CONVAIR

COMMERCIAL CHANGE PROPOSAL

CUSTOMER: Delta Air Lines Inc.

MODEL: 22-2 (Convair "880")

MOD 22
MAIN WHEEL
EMERG BRAKE
STORAGE PRESSURE

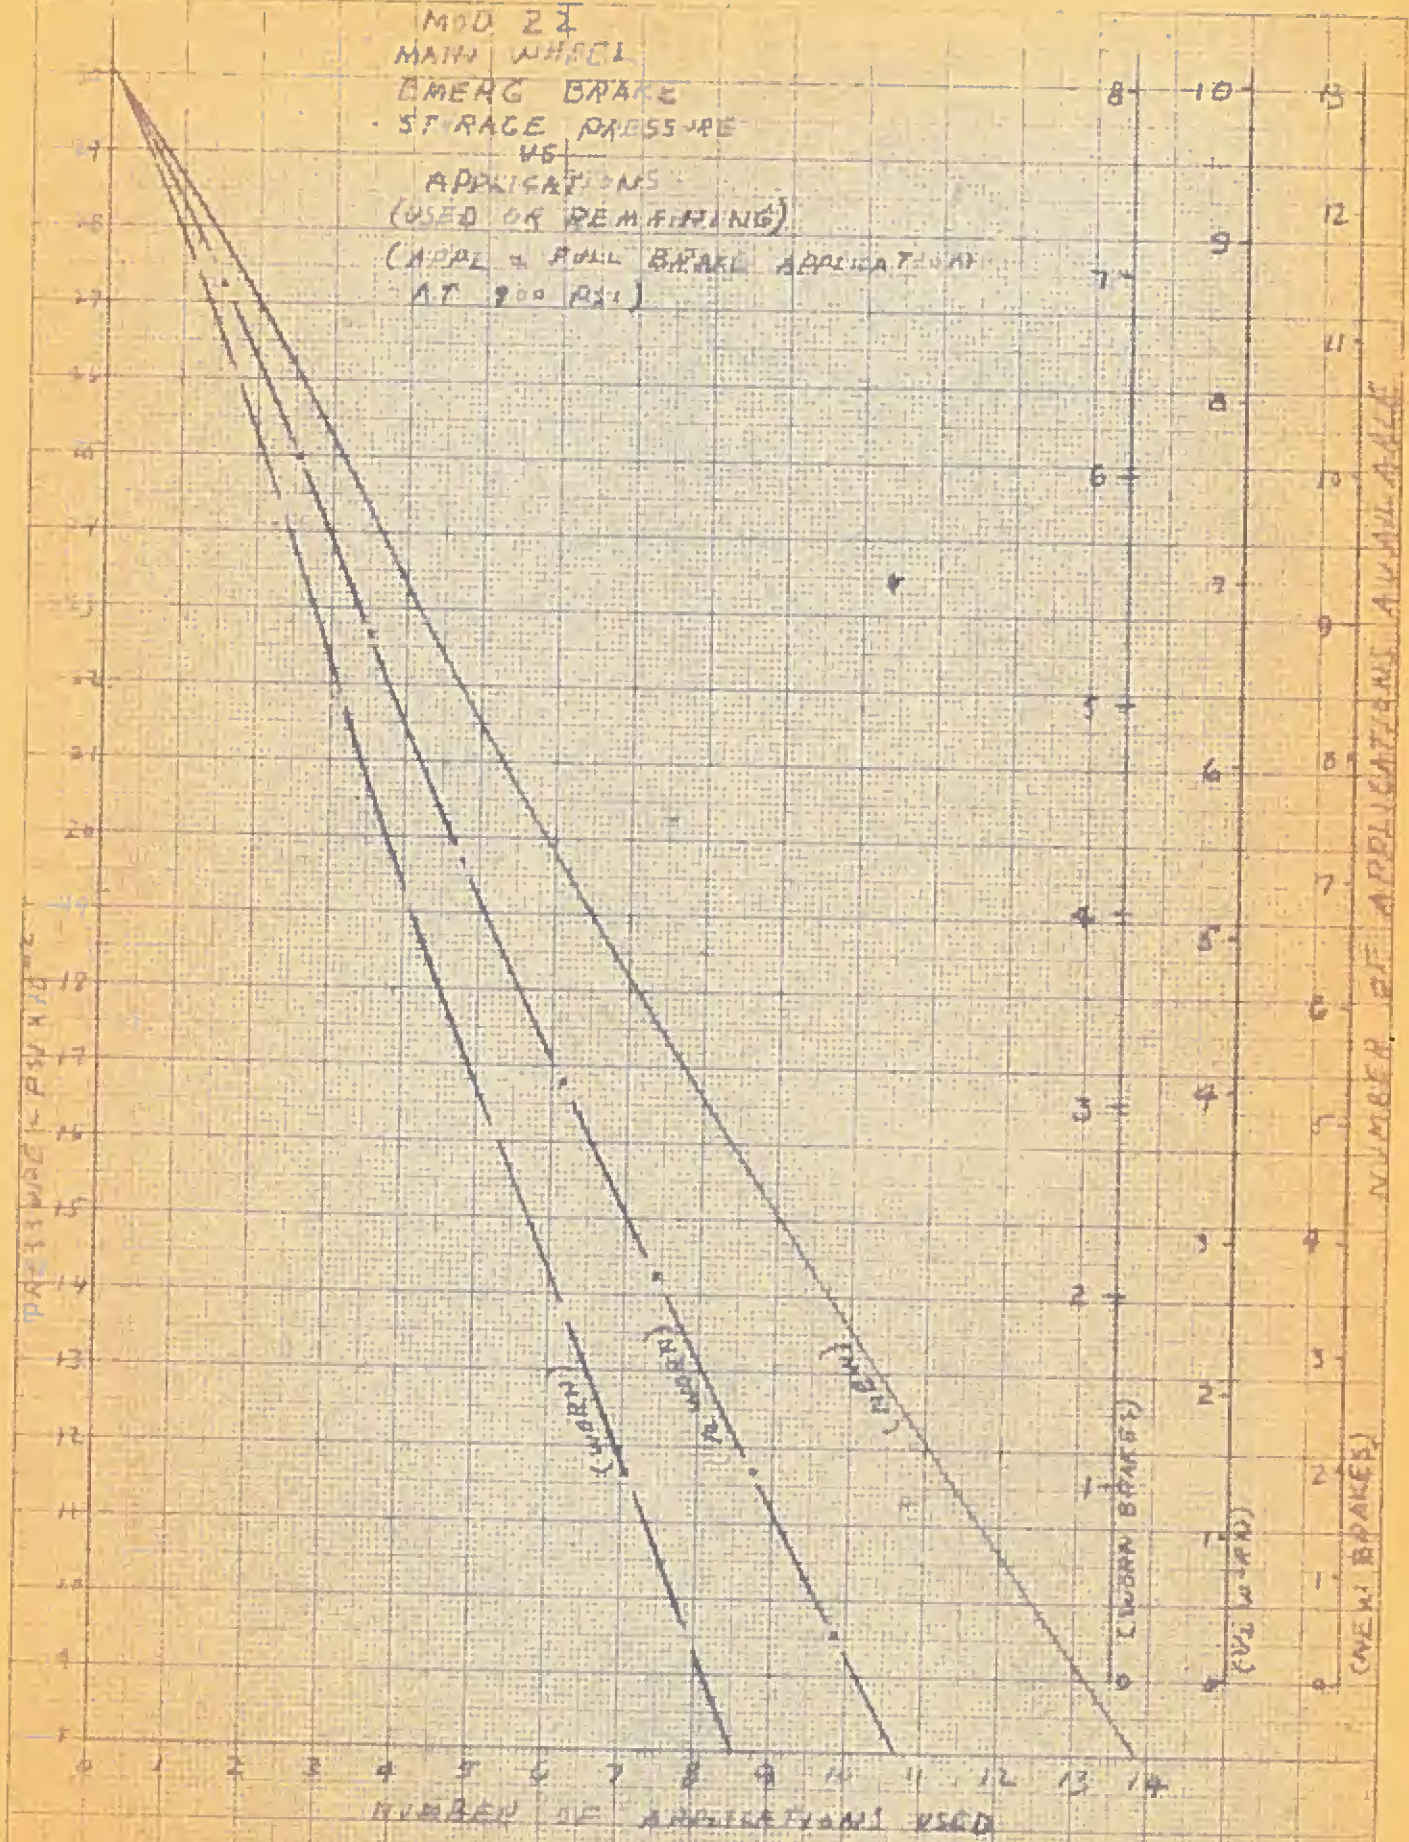
Title: Specification Administrative Change (Change Emergency
Brake Cylinder from 400 to 300 Cubic Inches)

Reason for Change: Replacement of the fiber glass air flask
(2,200 psi) with the ICC steel flask
(3,000 psi) made it necessary to reduce
the cylinder volume from 400 to 300 cubic
inches.

HEAD REST. ATTEND.	SK 22-12289-1	
SEAT- PROPOSAL	DIETZ	12/20, 59

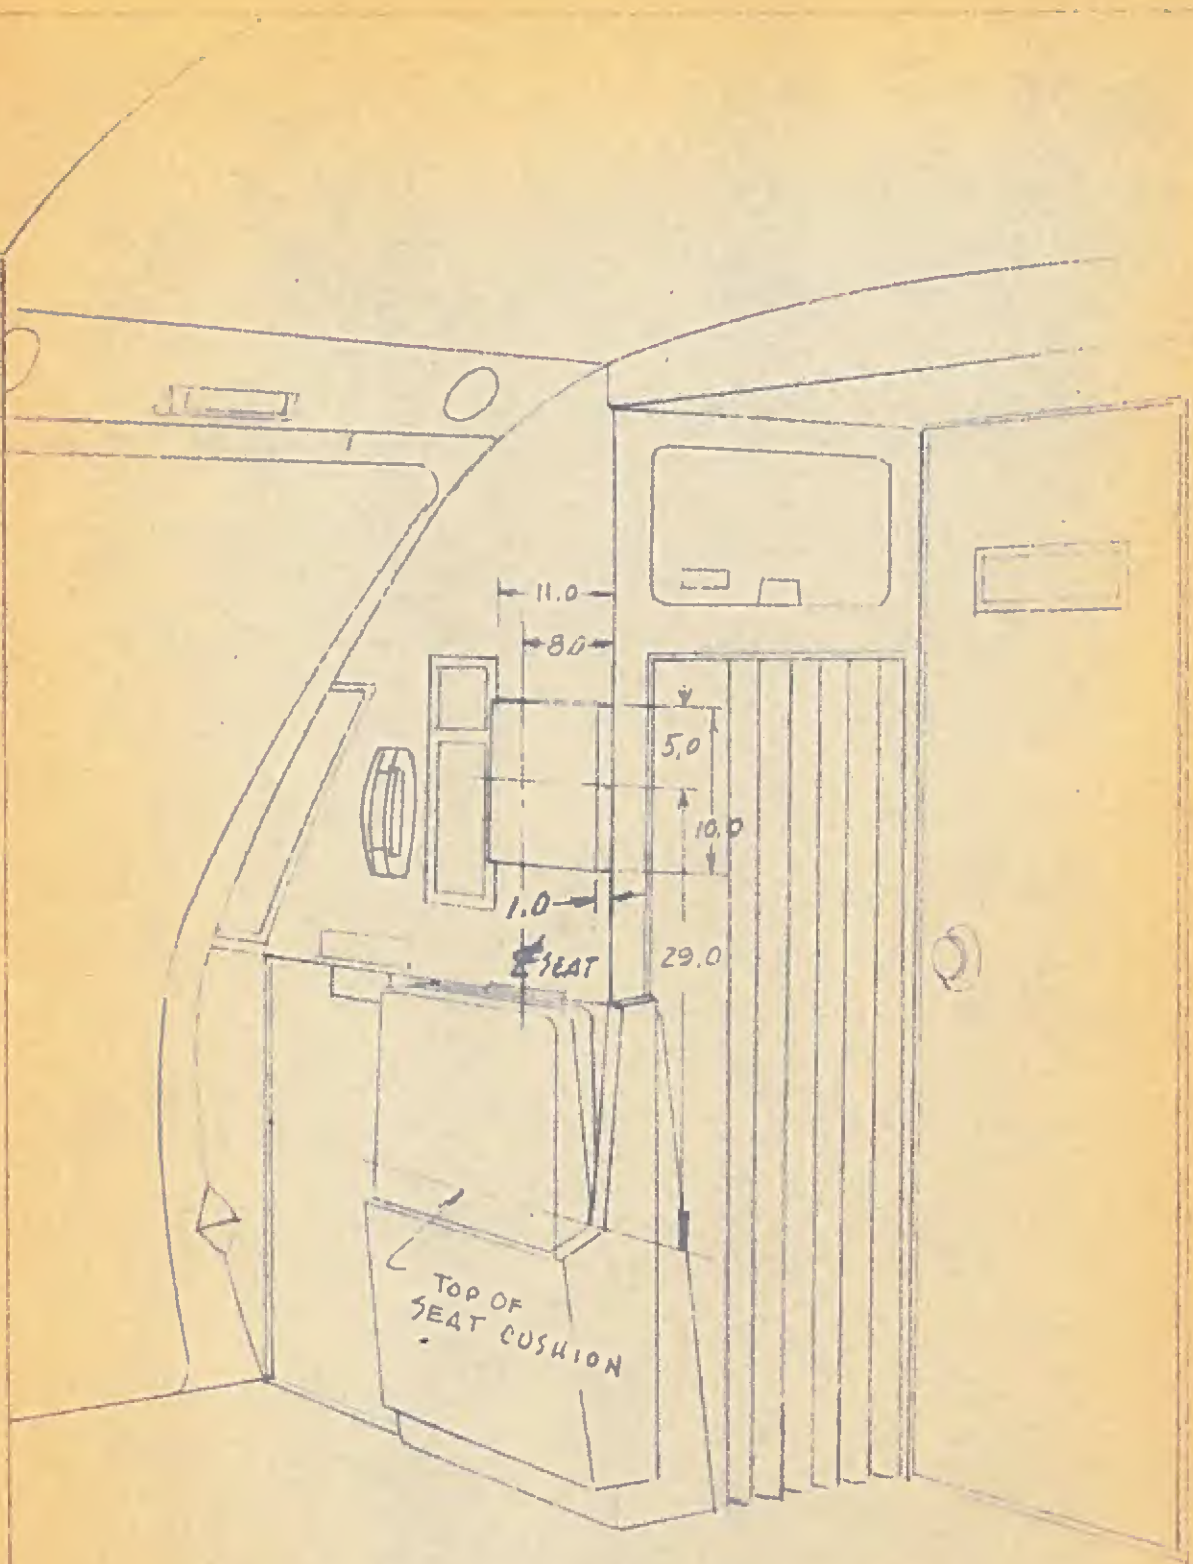
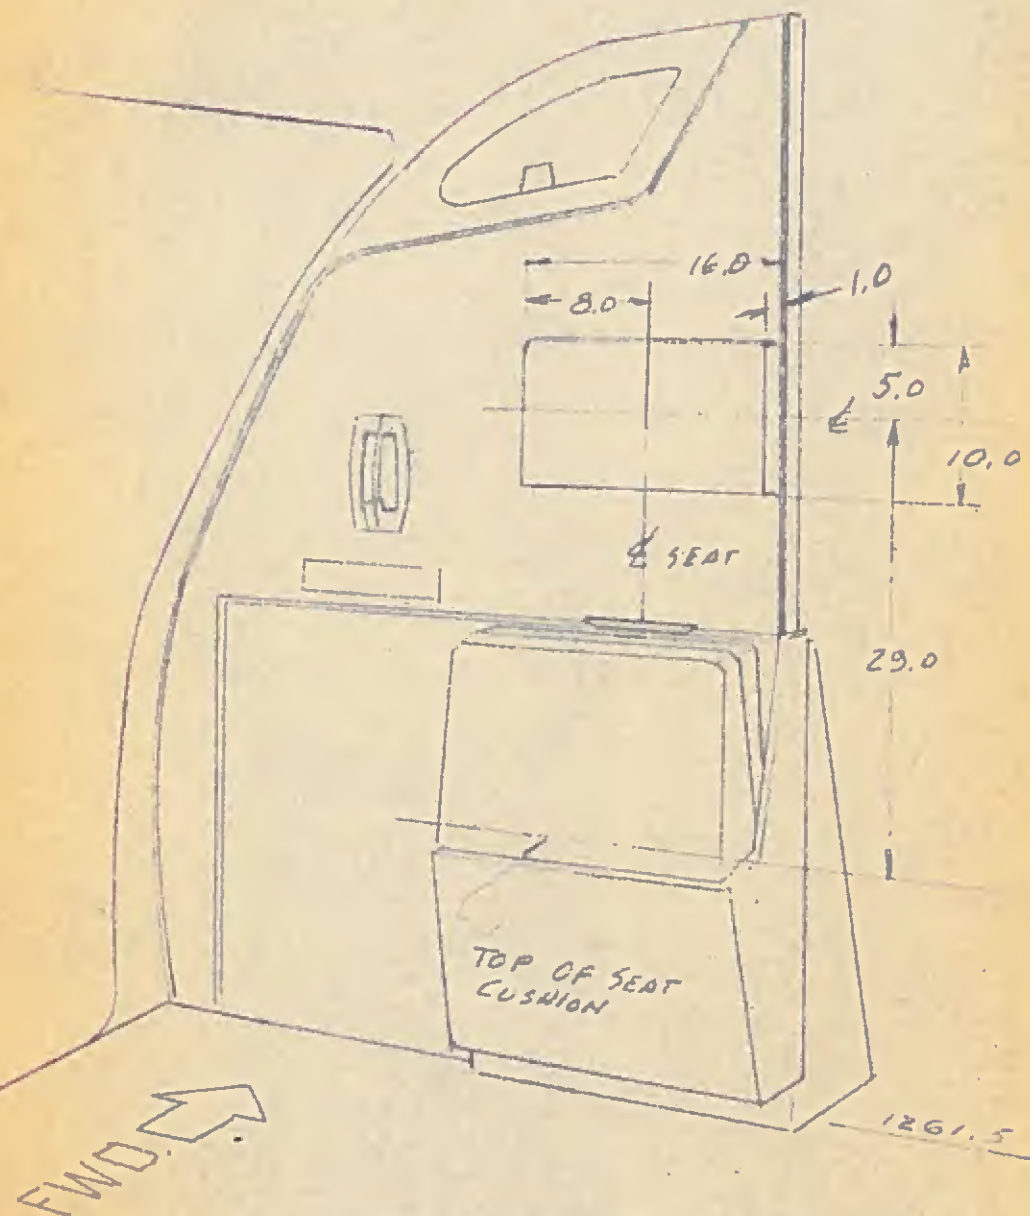
Page 104, Paragraph 3.19.1.1.4 CABIN ATTENDANTS' SEATS:

Add the following to the end of the paragraph:

"An upholstered, detachable head rest shall be installed, one each on the aft face of the forward left hand coat compartment and on the left hand aft bulkhead for use of the aft facing cabin attendants."

- ENCLOSURES: (A) Convair Sketch - HEAD REST, ATTENDANT SEAT, FWD. ENTRY COMPARTMENT (For information only.)
- (B) Convair Sketch - HEAD REST, ATTENDANT SEAT, AFT ENTRY COMPARTMENT (For information only.)

FIGURE 3.1-1

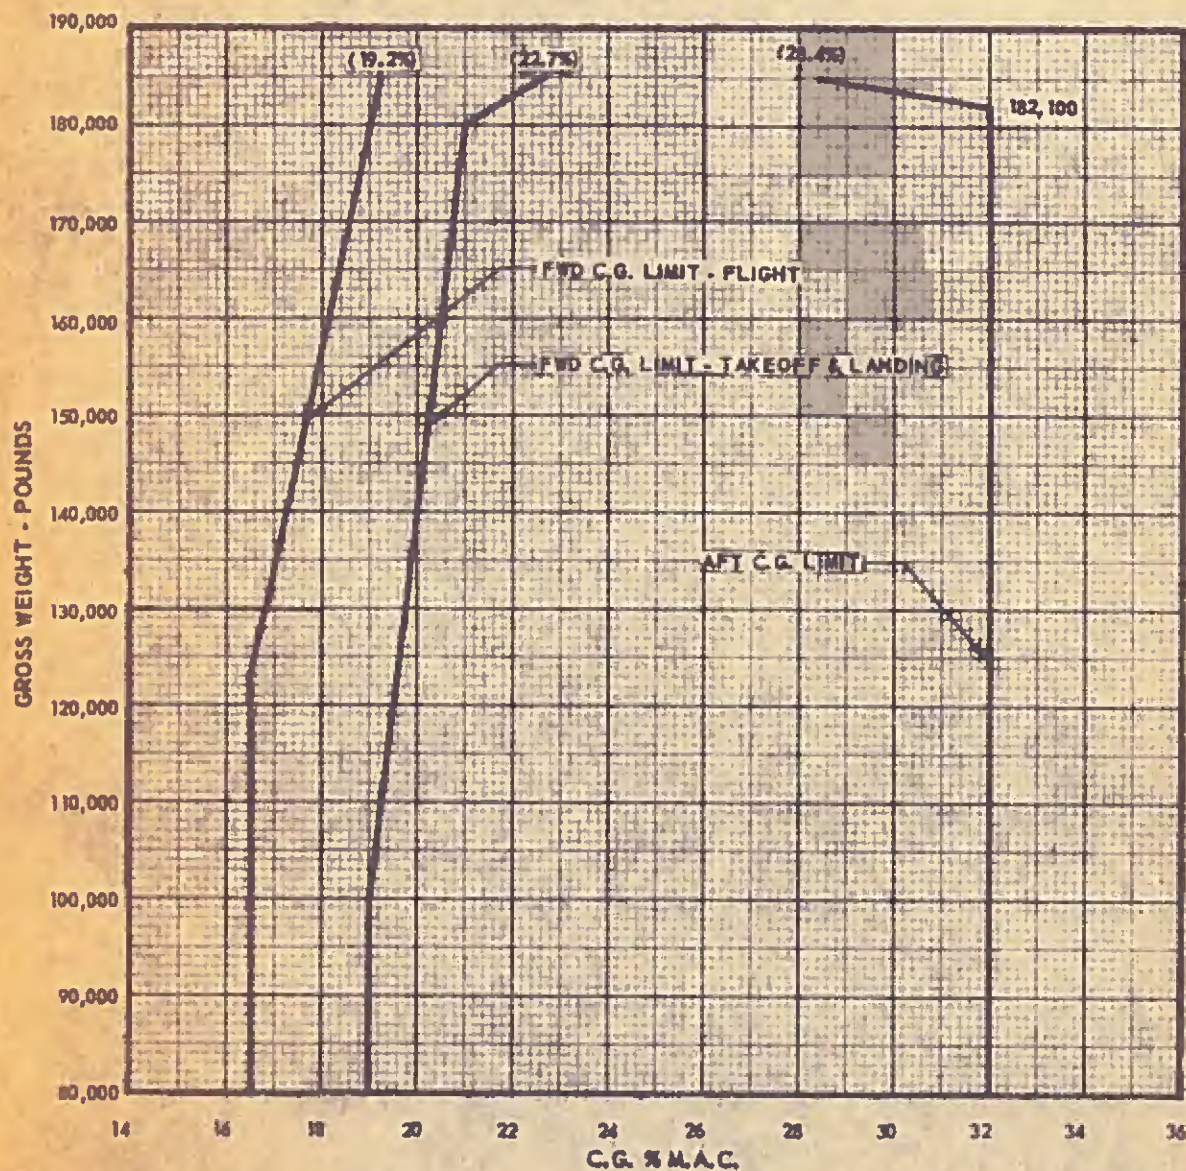
Page 12a, CENTER OF GRAVITY LIMITS

Replace above graph in specification with Enclosure: (A):

Enclosure: (A) One copy Page 12a, CENTER OF GRAVITY LIMITS
(Revised)

Enclosure: (A) One copy Page 38a - MAIN LANDING GEAR SYSTEM (Revised)
(B) One copy Page 38b - WHEEL BRAKE (Revised)

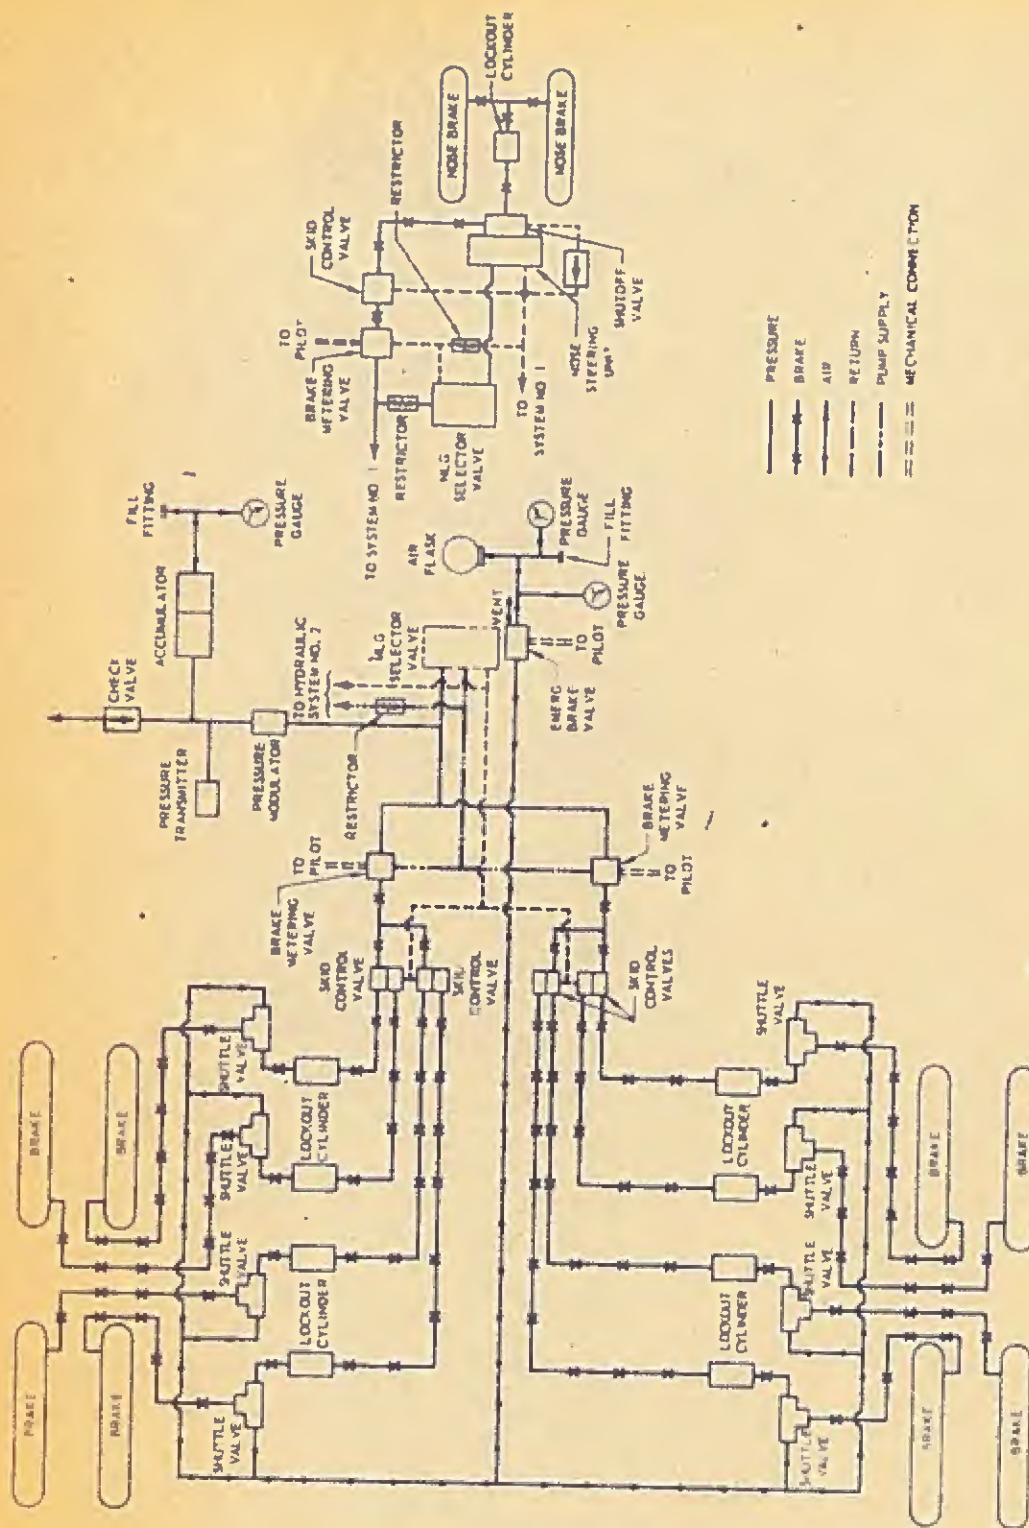
Page 35, Paragraph 3.8.2.5 RETRACTING, EXTENDING AND LOCKING SYSTEMS;

Delete the paragraph and substitute the following:

"Landing gear retraction shall be accomplished hydraulically to a point where the gear is within the wheel well cavity and the landing gear doors are closed in a maximum of ten seconds with four engines operating. Under three-engine operation conditions, the gear retraction cycle shall not exceed 12 seconds."

FIGURE 3.1-3

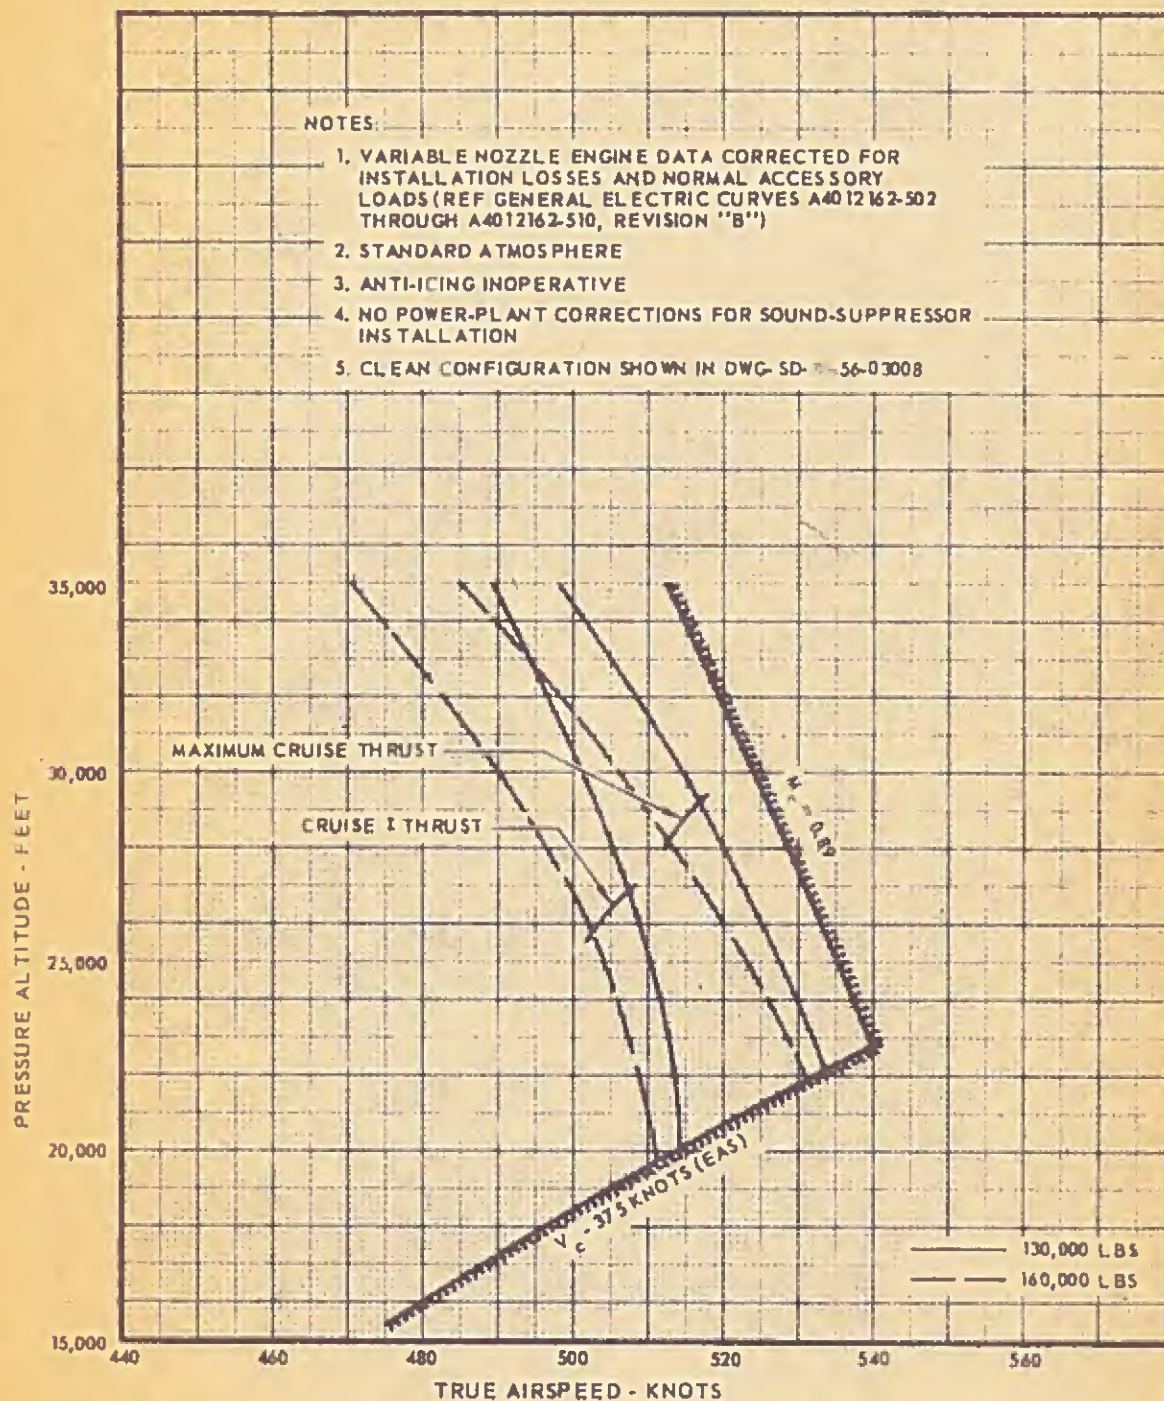
Page 12C, FIGURE 3.1-3 - MAXIMUM LEVEL FLIGHT SPEEDS
Page 56A, FIGURE 3.12-1 - ENGINE STARTING SYSTEM
Page 62C, FIGURE 3.14-3 - FLIGHT ENGINEER'S PANEL
Page 62D, FIGURE 3.14-4 - PILOT'S & COPILOT'S OVERHEAD CONTROL PANEL
Page 89A, FIGURE 3.16-1 - A-C POWER SYSTEM
Page 89B, FIGURE 3.16-2 - D-C POWER SYSTEM
Page 102D, FIGURE 3.17-2 - PITOT STATIC SYSTEM
Page 115A, FIGURE 3.19-1 - TEMPERATURE MEASUREMENT PLANE
Page 122A, FIGURE 3.20-1 - AIR CONDITIONING PRESSURIZATION SYSTEM
Page 122B, FIGURE 3.20-2 - ESTIMATED CABIN PRESSURE SCHEDULE
Page 122C, FIGURE 3.20-3 - TEMPERATURE VS ALTITUDE
Page 122D, FIGURE 3.20-4 - CABIN AIR CONDITIONING SYSTEM PERFORMANCE

One revised copy each of the above illustrations is attached hereto for Customer approval and subsequent incorporation into specification.
